REVISION DESCRIPTION:

Kit Assembly Instructions:

FIGURE 1: PLACARDS FOR TURTLE DECK SKIN AND AFT WINDOW

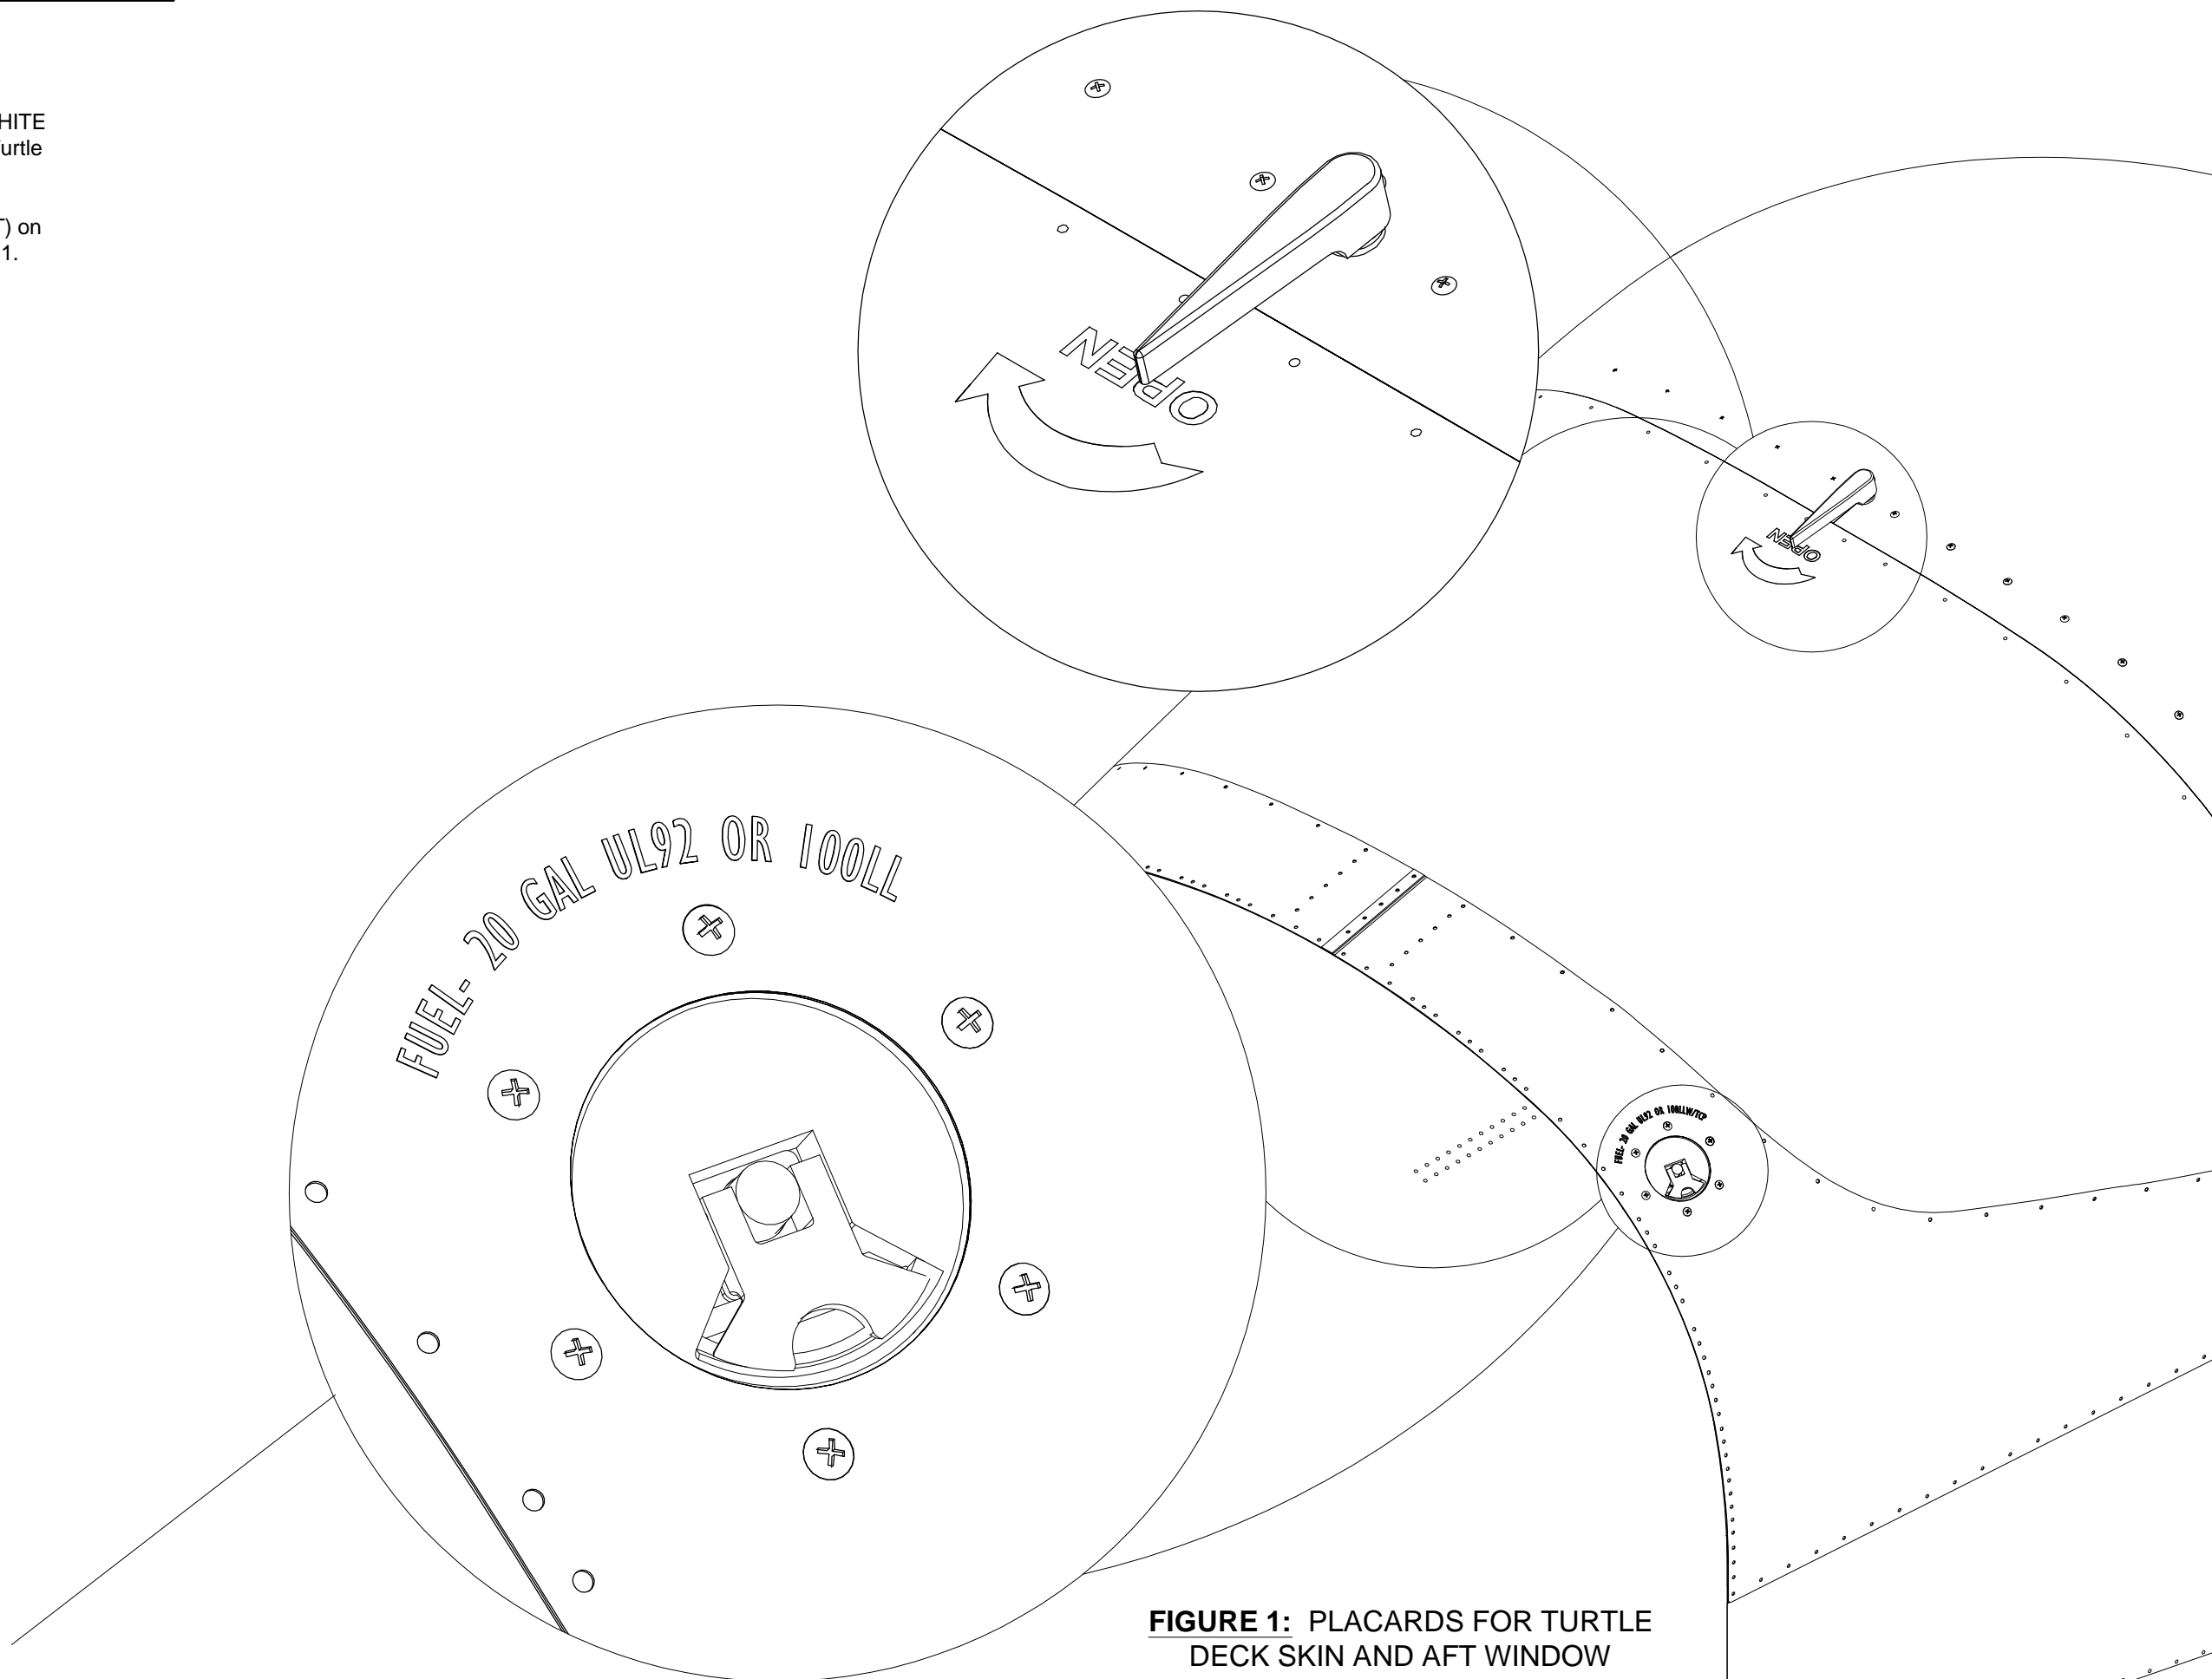
51-06 REV 3: Removed Step 3.

In Figure 1, Removed depiction of PLA-00017 BLACK or WHITE.
